## ASSESSMENT REPORT

### Section 75W Modification Orica Ammonia Nitrate Emulsion Project, Richmond Vale Water Tank and Storage Shed

The proposed modifications are illustrated in Figure 4 below.

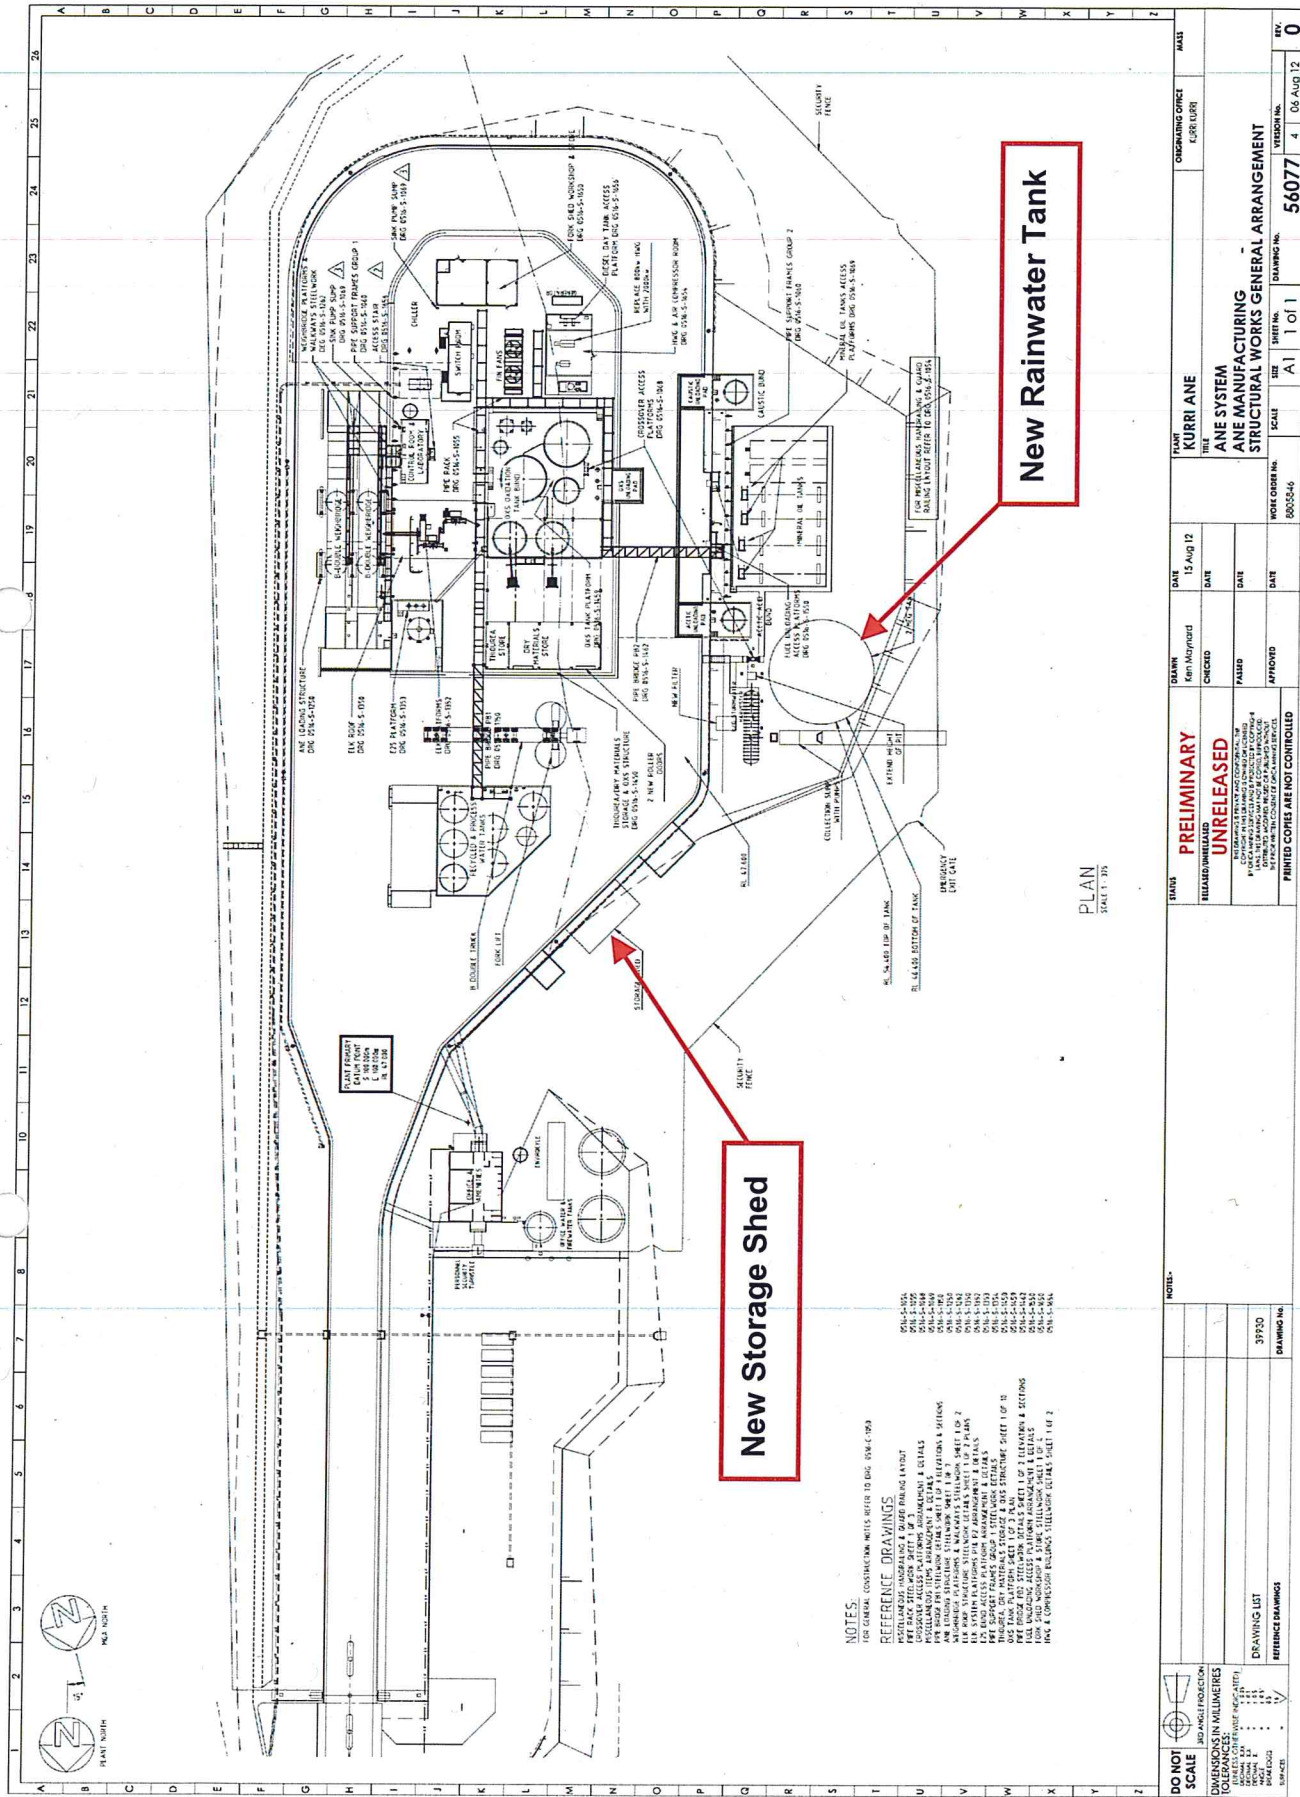
- a water storage tank (20 metre (m) in diameter by 8m high) with a capacity of two (2) mega litres to be located to the north of the existing mineral oil tanks; and
- a new storage shed with an area of approximately 132m<sup>2</sup> (17.7m long by 7.4m wide by 4.75m high) to the south of the existing office and amenities for storage of spare parts, archives and safety equipment for the ANE plant.

The water storage tank would capture rainwater that falls anywhere within the bunded area around the ANE plant which at present, flows directly off-site into surrounding bushland during high rainfall events. Rainwater that falls in this area would be collected to a collection sump that pumps water directly to the tank.

The tank would be constructed using painted steel panels bolted together with an internal rubber bladder. A concrete ring beam would be constructed to mount the base of the tank to allow stabilised assembly of ring panels.

The storage shed would be a steel frame construction with sheet metal walls and roof and a 'roll-a-door' entrance.

<b>Bushfire Risk</b>	<ul style="list-style-type: none"> <li>The site is bushfire prone and as a result, a 30m wide Asset Protection Zone (APZ) was established around the ANE plant.</li> <li>The new water tank would extend approximately 3 to 4 metres into the APZ on the western side of the ANE plant.</li> <li>However, the Bushfire Threat Assessment (BTA) prepared as part of the original EA for the ANE project recommended an APZ of at least 25m on the western side of the ANE plant.</li> <li>Therefore, despite the intrusion of the water tank into the current APZ of 30m, an APZ of 25m would be retained which is considered to be adequate to ensure the facility is not at risk during a bushfire.</li> <li>In addition, the water tank would be constructed of concrete and steel and is not at risk of catching alight during a bushfire.</li> <li>The Department is therefore satisfied that the proposed modification would not increase bushfire risk.</li> </ul>	<p>Manage through existing conditions of approval which require Orica to:</p> <ul style="list-style-type: none"> <li>Implement the recommendations of the BTA included with the EA.</li> </ul>
